Addendum NO 1

DATE: May 11, 2020

FOR: **Pike County BRO-B082(31)**

R. 135 BRIDGE #0510014 (BRO-B082(31))
PIKE COUNTY, MISSOURI

C4

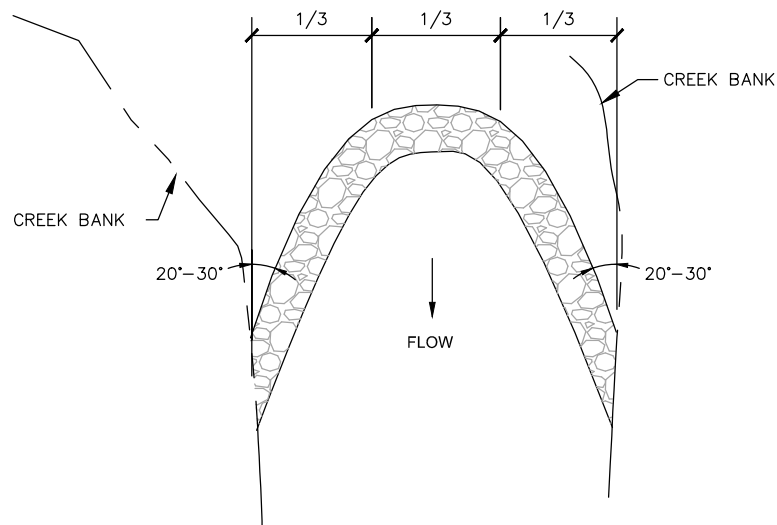
The Crashworthy End Terminal on the northeast corner of the bridge has been changed to Type A guardrail with an end horn.

C5

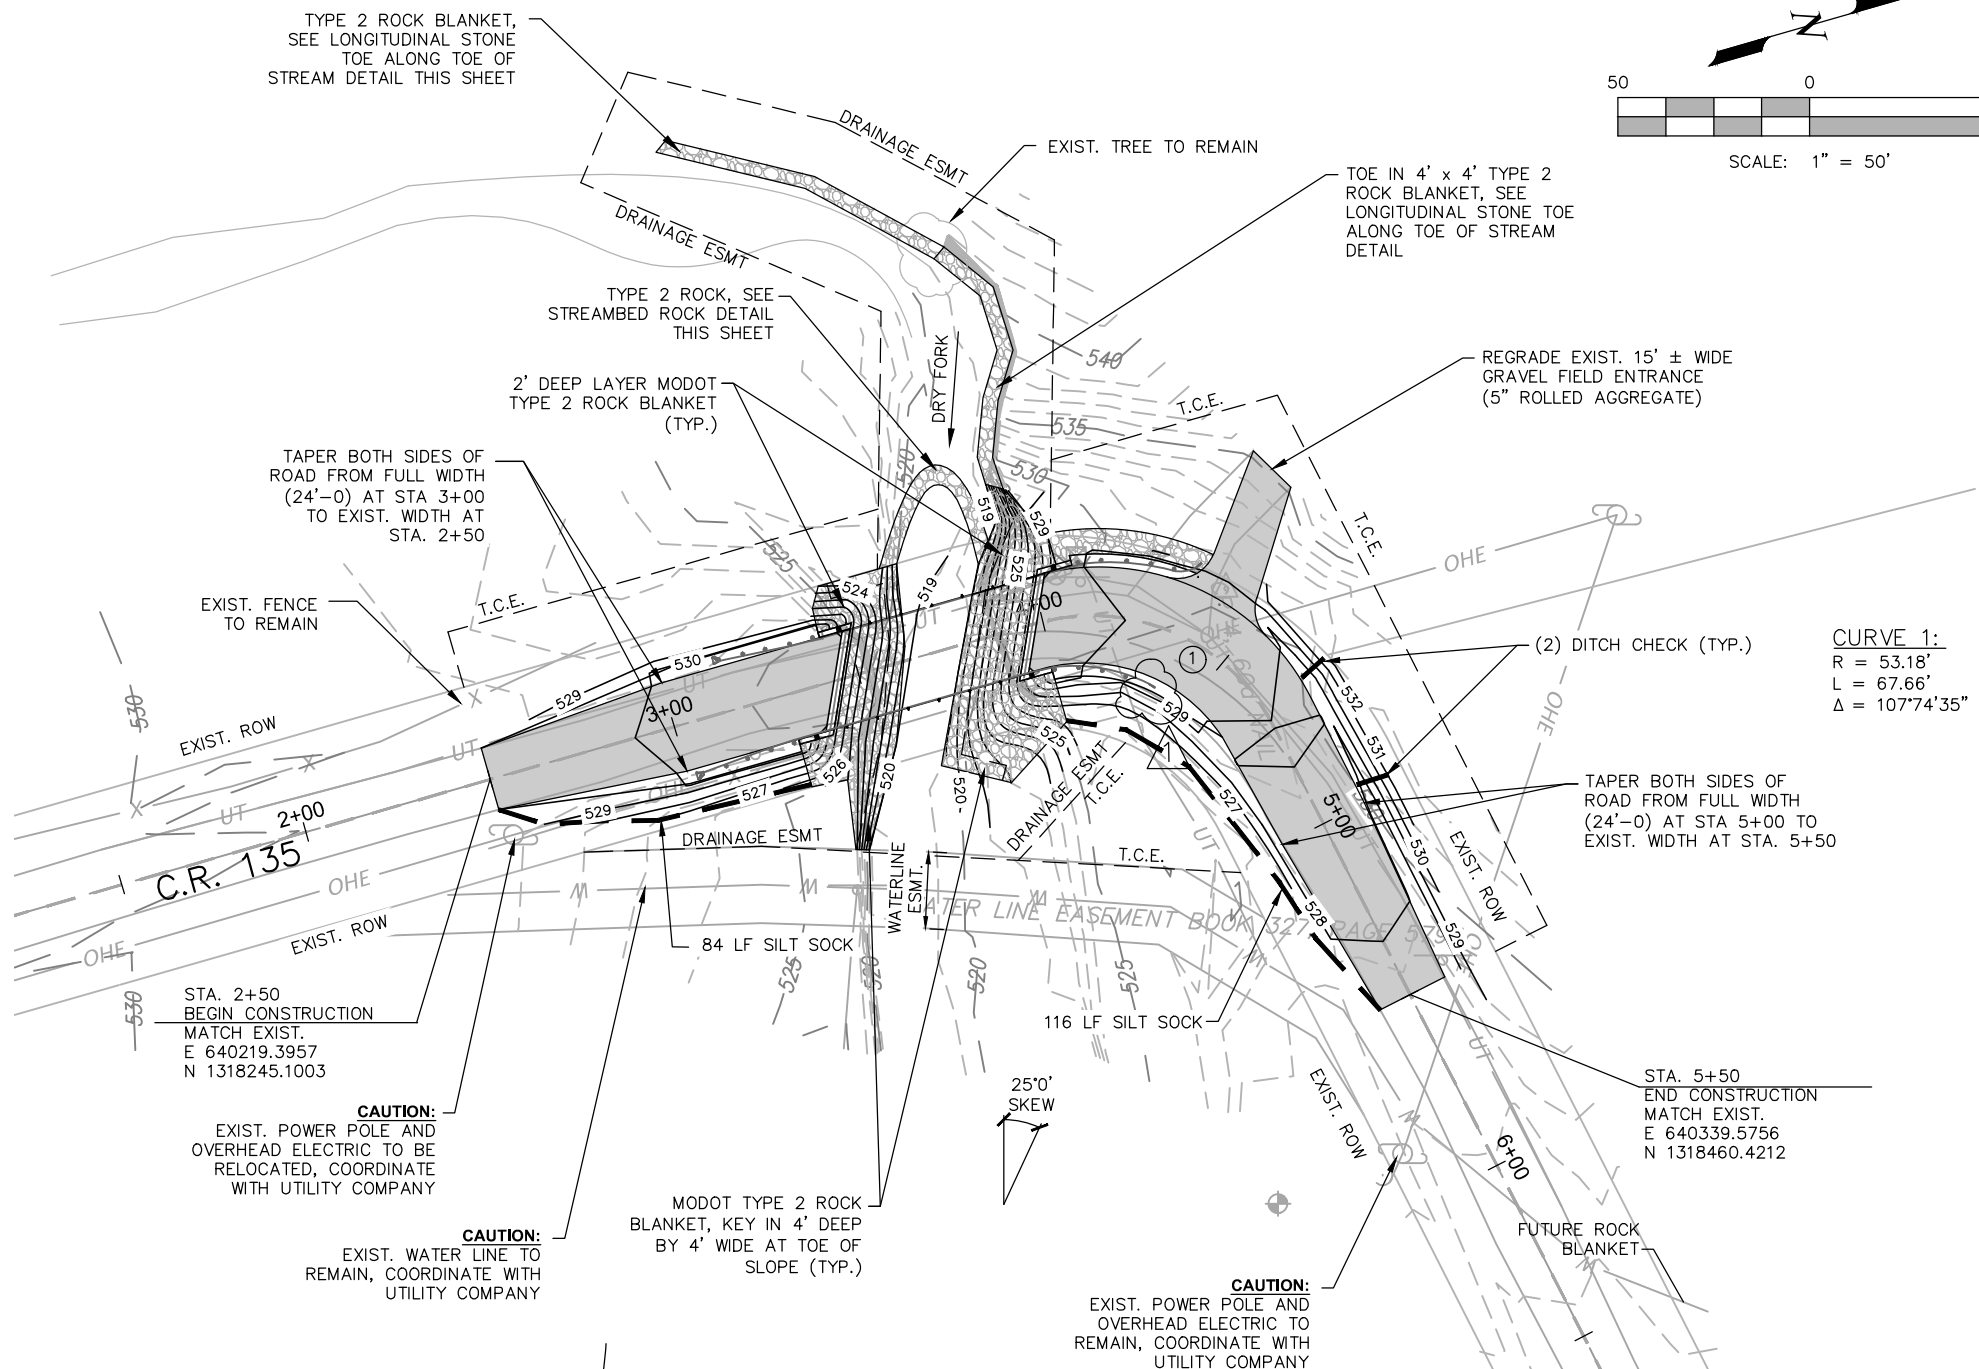
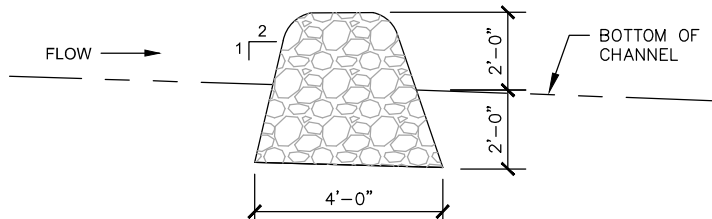
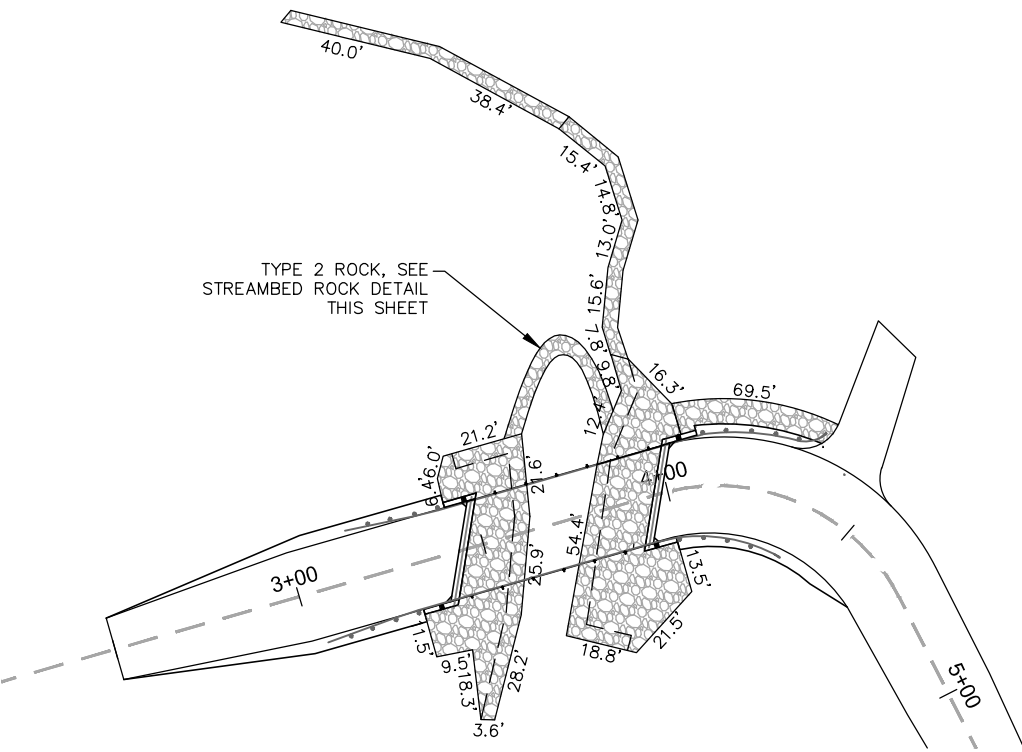
The Crashworthy End Terminal on the northeast corner of the bridge has been changed to Type A guardrail with an end horn.

GUARDRAIL LOCATION PLAN

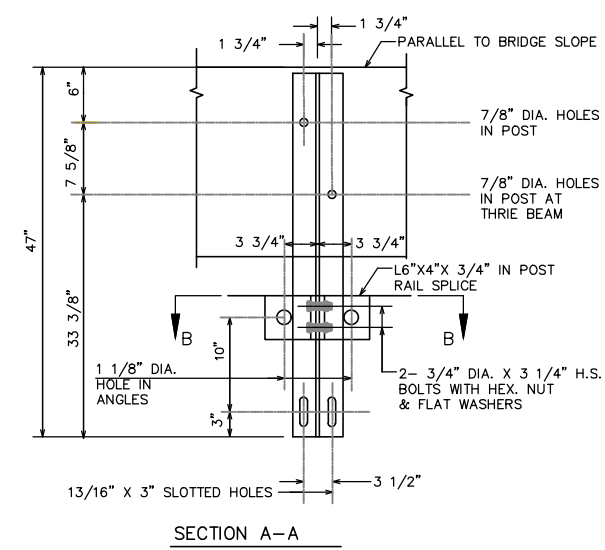
The Crashworthy End Terminal on the northeast corner of the bridge has been changed to Type A guardrail with an end horn.
